**IronHorse  
Design Guidelines  
Addendum #1  
August 28, 2008**

The following revisions, deletions and additions are hereby incorporated into the March 2007 IronHorse Design Guidelines:

**IronHorse Design Guidelines Review**  
**October 17, 2008**

1. Design Guidelines, Page 7 Prototype Table. Add footnote "(14)" and "(16)" to the Setbacks heading. Under the Garage Front Min. heading: Cells N.1 N.2, N.3 and N.4 shall read "8 feet behind the front of the home (15)."

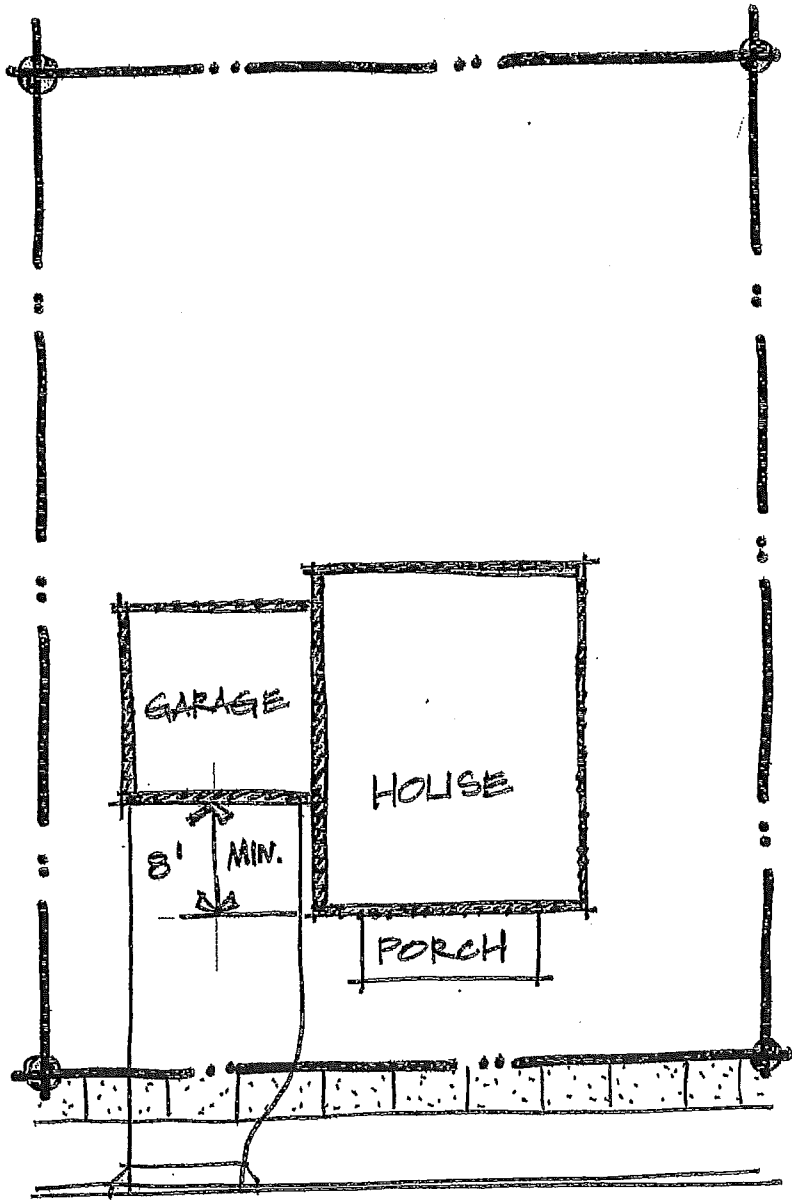
Add footnote: "14. The ARC, in its sole authority and discretion, may approve setbacks that vary from this chart (however, the City of Prineville's standards shall take precedence) for homes on lots with one or more of the following: significant slope, irregular shape, easements (as recorded on the original plat), significant trees or rock outcroppings and other site conditions or constraints."

Add footnote: "15. For lots without alley access and one or more of the following: significant slope, irregular shape, easements (as recorded on the original plat), significant tree(s) location(s) or rock outcropping location(s) and other site conditions or constraints the ARC may approve, in its sole authority and discretion, garages (with garage doors facing the street) less than 8 feet (see exhibits A and B). However, in no case shall the ARC approve a garage less than 4 feet behind the front of the home. Garages less than 8 feet behind the front of a home will require architectural enhancements such as "carriage house" type garage door(s), trellis and/or other architectural enhancements to mitigate for the garage location. The ARC may also approve homes with garages with the garage doors more or less perpendicular to the right of way or more or less radial on arcing/curving sections of the right of way (see exhibit C). This alternate garage configuration (exhibit C) will require architectural enhancements and may require additional front yard landscaping."

# EXHIBIT C

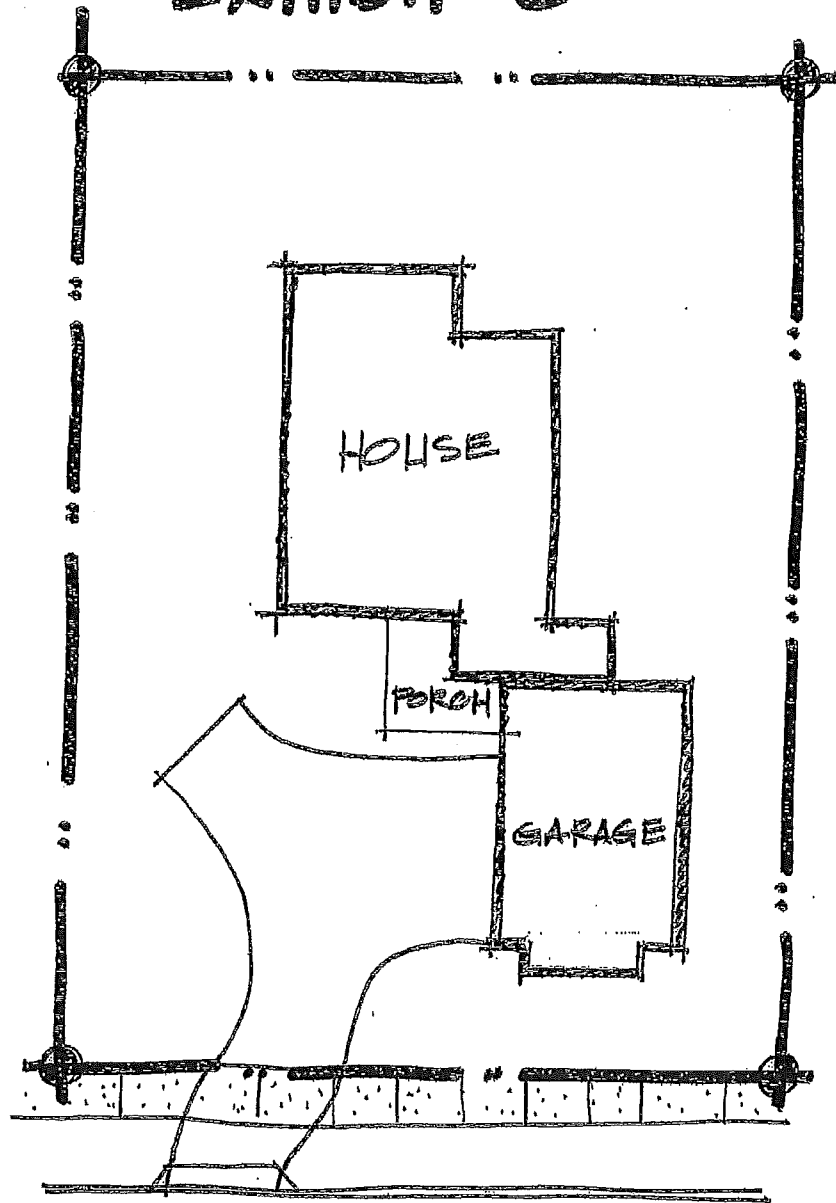
THIS CONFIGURATION WILL  
REQUIRE THE STREET FACE OF  
THE GARAGE TO HAVE ARCHITECTURAL  
ENHANCEMENTS; ADDITIONAL  
LANDSCAPING MAY ALSO BE  
REQUIRED.
